# RCA-60-23-001-1: Improved Fender Liner and Front Subframe Underbody Panel Clearance

<b>Document Type</b>	Customer Satisfaction Campaign Bulletin
<b>Date</b>	November 8, 2023
<b>Affected Region(s)</b>	USA
<b>Affected Model(s)</b>	R1T
<b>Model Year(s)</b>	2022
<b>Approximate Build Dates</b>	August 2021 - December 2021
 Refer to <b>Open Containments</b> in ServiceOS to determine if this document applies to a specific vehicle.	
<b>Vehicle System</b>	60 - Exterior Attachments
<b>Minimum Service Location</b>	Mobile

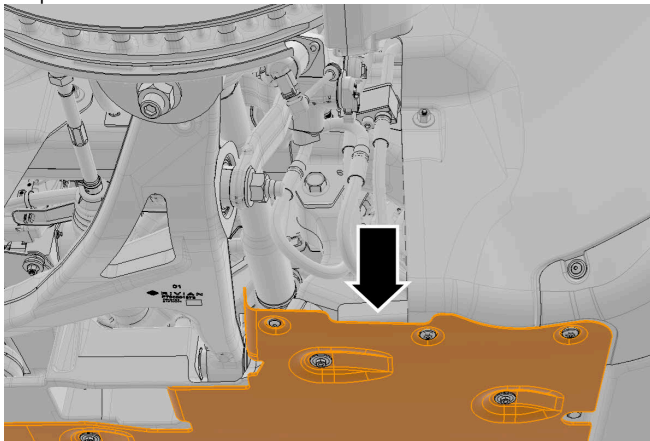
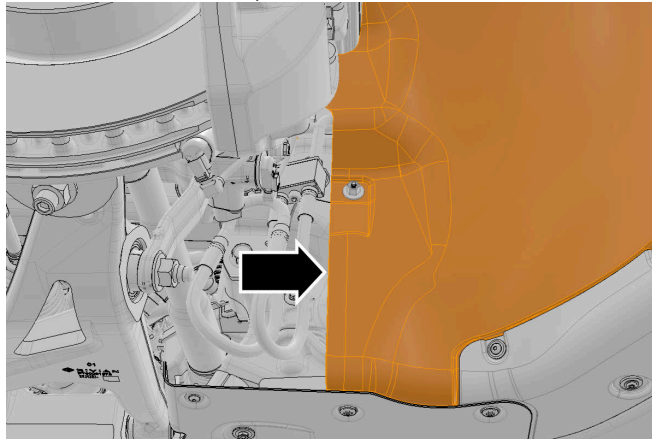
1. Raise and Support Vehicle (refer to service manual procedure 981020017).
2. On both sides of the vehicle: Inspect the highlighted component for a notch in the indicated area.
  - If there is no notch: Replace: Panel, Underbody, Front Subframe (refer to service manual procedure 606515010).

- If there is a notch: The underbody panel does not need to be replaced. Continue to the next step.

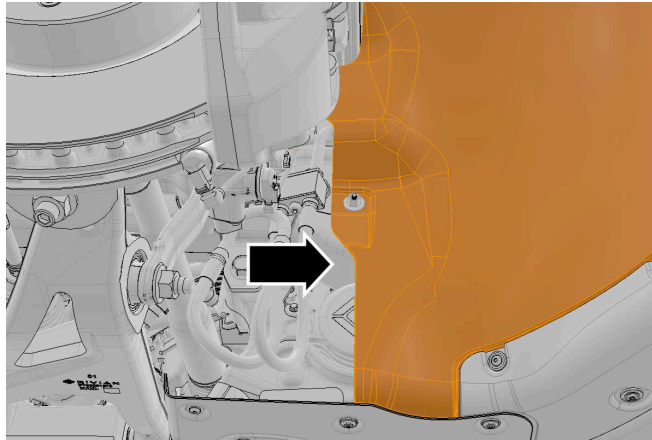
3. On both sides of the vehicle: Inspect the highlighted component for a notch in the indicated area.
  - If there is no notch: Replace: Liner, Wheel, Front (refer to service manual procedure 607610010).

- If there is a notch: The fender liner does not need to be replaced. Continue to the next step.
